# Planning and Zoning Commission

## Cosgray Commons 26-006Z-PDP

Address	PID: 274-000010-00 & 16-0001001.0000
Proposal	Informal review and feedback for a <u>future</u> Preliminary Development Plan (PDP) application of a mixed-use development comprised of office, residential, commercial and open space. The 44.6-acre site consists of two parcels and is located southwest of the roundabout at Post Road/State Route 161 (SR-161) and University Boulevard.
Request	Informal review and feedback of a future development Preliminary Development Plan and Rezoning application.
Zoning	ID-2 – Research Flex District
Planning Recommendation	<u>Consideration of the discussion questions</u>
Next Steps	Upon receiving feedback from the Planning and Zoning Commission (PZC), the applicant may incorporate the feedback and submit for a PDP.
Applicant	Mike Suriano; NBBJ
Case Manager	Christopher Will, Senior Planner; 614-410-4498; cwill@dublin.oh.us

# 26-006Z-PDP - Cosgray Commons

Current Proposed Development Plan

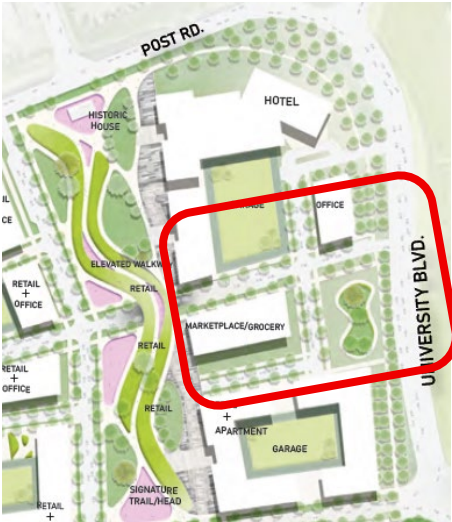
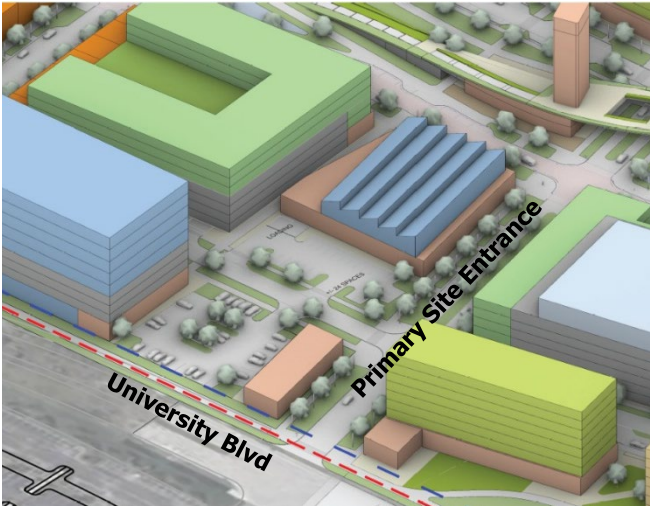
Southwest of the proposed intersection of University Boulevard and a primary site access the applicant is proposing the single-story building (D2) and associated surface parking which directly fronts University Boulevard. Also proposed is a small surface parking lot and loading zone for the D1 building (commercial/grocery/office) also facing University Boulevard. These are the only surface parking lots proposed within the development, and no additional setback or landscaping is provided along the lot directly in front of University Boulevard.

The proposed development is opposite the location identified in the OU Framework Plan for establishing a signature building fronting University Boulevard at the west terminus of the campus green. The proposed surface parking lots in this location may not complement the campus vision. In previous site concepts reviewed by the Commission, this area was shown as open space, which Staff believes to be an appropriate condition.

Proposed surface lots and loading zone facing University Boulevard
